RANS

Airworthiness Directive: 122

Subject: 912/912S Oil Pressure Sender and Oil Pressure Switch

Models Effected: All Models using 912 and 912S Engines

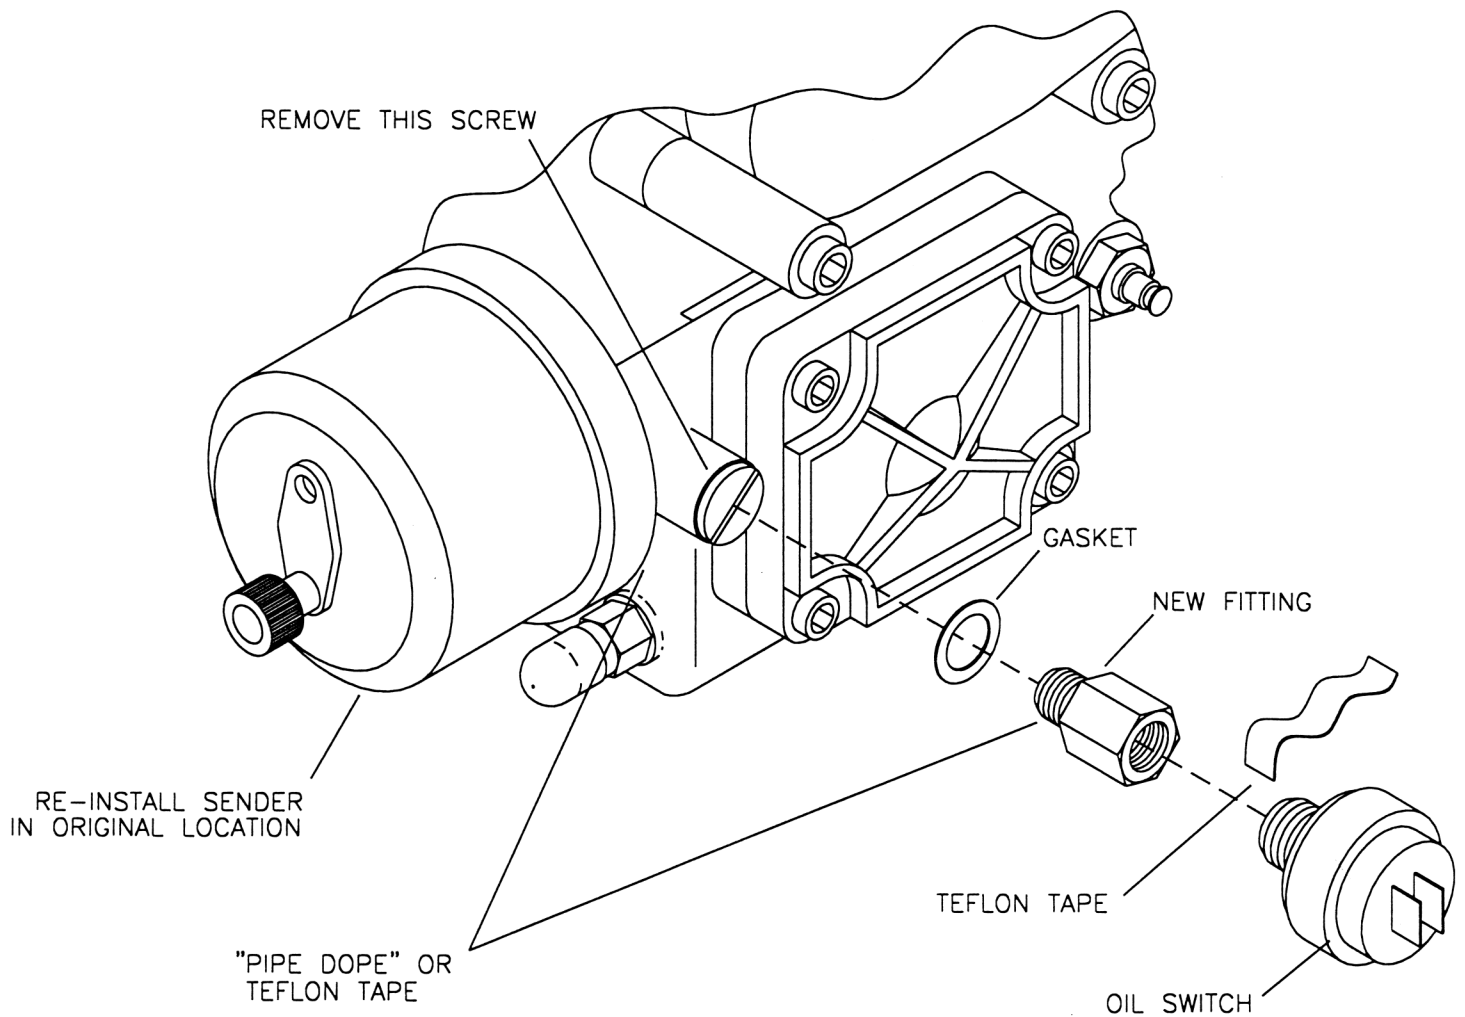
NOTICE: Inspect before your next flight for type of fitting retaining the oil pressure switch and oil pressure sender. If fitting is brass, please replace with new fitting, part number ADAPT1/8-10MM, as per this AD.

Steel fitting **does not** need to be replaced and can be identified by the hex shape between threads, see the attached figure drawings.

"CLOSED NIPPLE"
BRASS, REPLACE

NIPPLE-STEEL, NO
NEED TO REPLACE

1. Remove nipple, brass tee and switch, and sender units.
2. Re-install sender with "pipe dope" or teflon tape.
3. Remove the large flat head screw. **NOTE:** Save gasket under screw head
4. Slip gasket over new fitting and screw on with teflon tape or "pipe dope". Torque to **125 in lbs.**
5. Install oil switch, reconnect wires to both units
